**Comanche Peak Nuclear Power Plant, Units 3 & 4
COL Application**

FSAR Revision1

Update Tracking Report

Revision 7

Figure 2.4.13-201 Bounding Horizontal Travel Path for BAT Failure Analysis

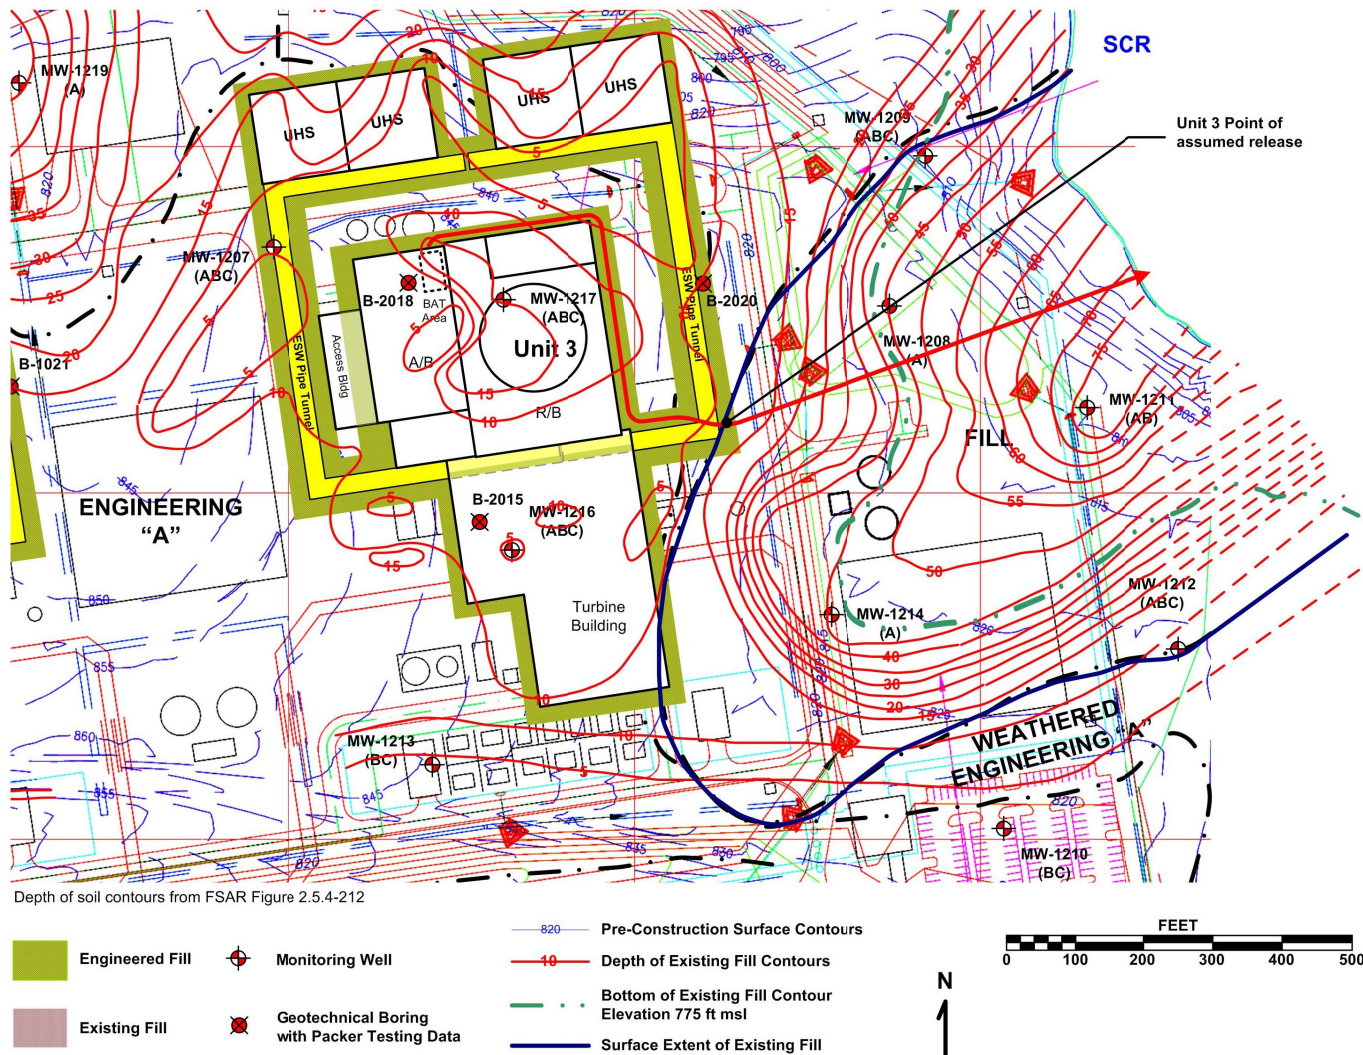
RCOL2_02.04.13-7	Figures 2.4.13-201 2.4.13-202 2.4.13-203 2.4.13-204 2.4.13-205 2.4.13-206 2.4.13-207	-	Response to RAI No 145 Luminant letter TXNB-10063 Date 9/16/2010	New figures added to reflect new subsection 2.4.13.5 discussion.	-

Figure 2.5.4-202 Exploration Locations

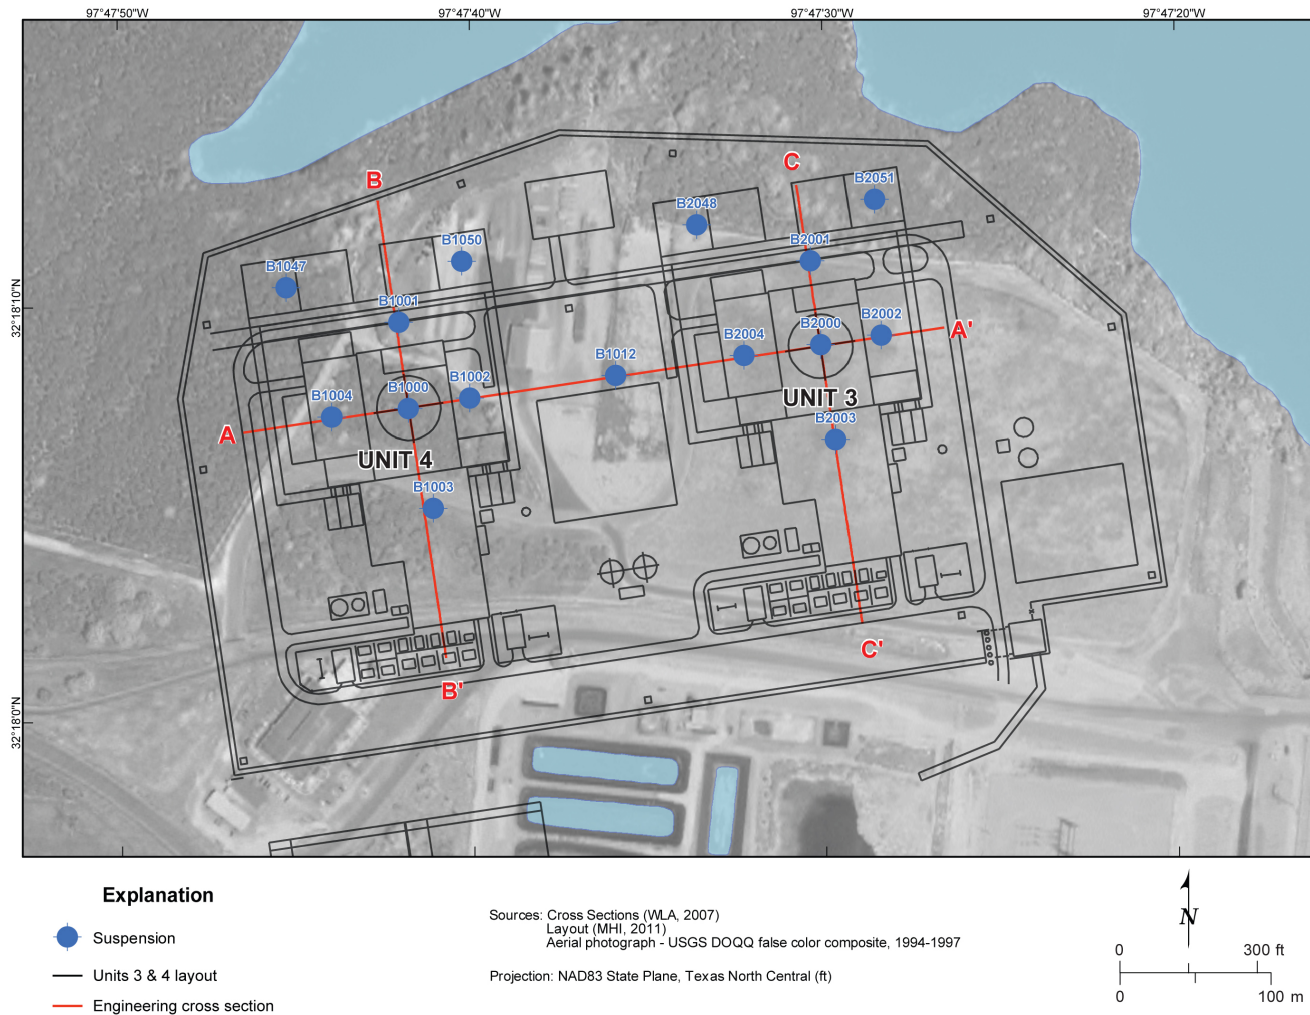
Change ID No.	Section	FSAR Rev. 1 Page*	Reason for change	Change Summary	Rev. of FSAR T/R
MAP-02-306	2.4.14	2.4-75 [2.4-114]	Consistency with DCD Revision 3	Pluralized "Specification" in title	7
CTS-01258	Table 2.4.12-211	2.4-169 [2.4-220]	Clarification	Revised table to clarify fill conductivity ratio for path 1 and path 2 concerning postulated release for Unit 3 and 4	7
MAP-00-301	Figure 2.1-201 2.3-380 2.4-2-202 2.4.12-208 2.4.12-210 (Sheet 1,2,3 and 4) 2.4.12-212 2.4.13-201 2.5.4-202 2.5.4-203 2.5.4-212 2.5.4-213 2.5.4-214 2.5.4-215 2.5.4-216 2.5.5-201 2.5.5-204	-	Consistency with DCD Rev Revision3	Replaced FSAR Plot Plan figures	7

Figure 2.5.5-204 Site Grading Map

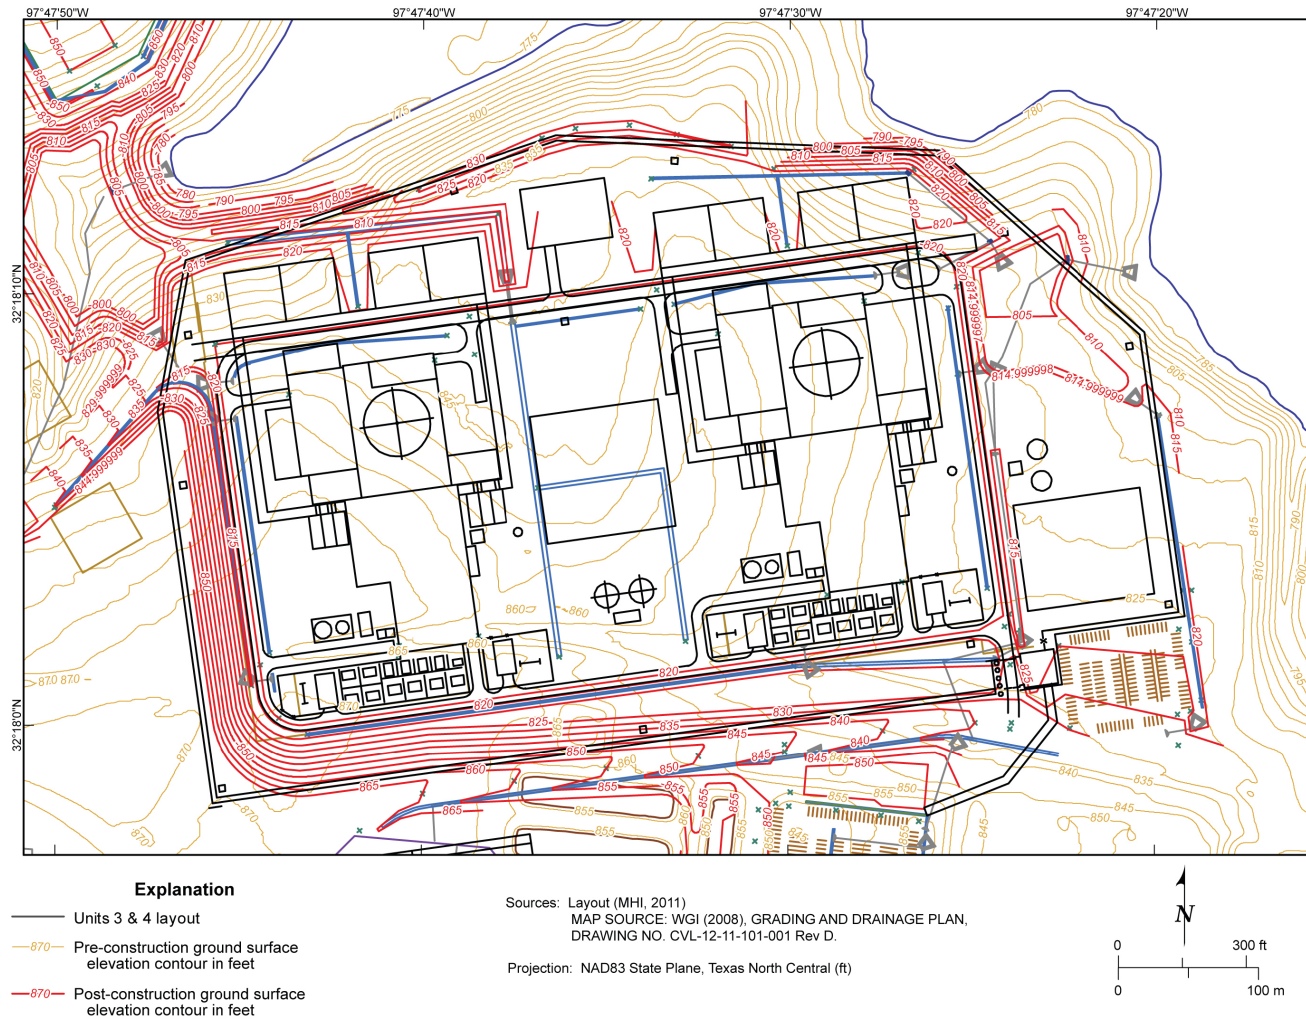
RCOL2_02.04.12-9	2.5.1.2.5.5	2.5-58	Response to RAI No 147 Luminant letter TXNB-10060 Date 8/26/2010	Revised subsection to describe groundwater consistent with the model described in revised subsection 2.4.12.	-
RCOL2_02.04.12-9	Figure 2.5.5-204	-	Response to RAI No 147 Luminant letter TXNB-10060 Date 8/26/2010	Revised figure to depict the current grading and drainage plan.	-
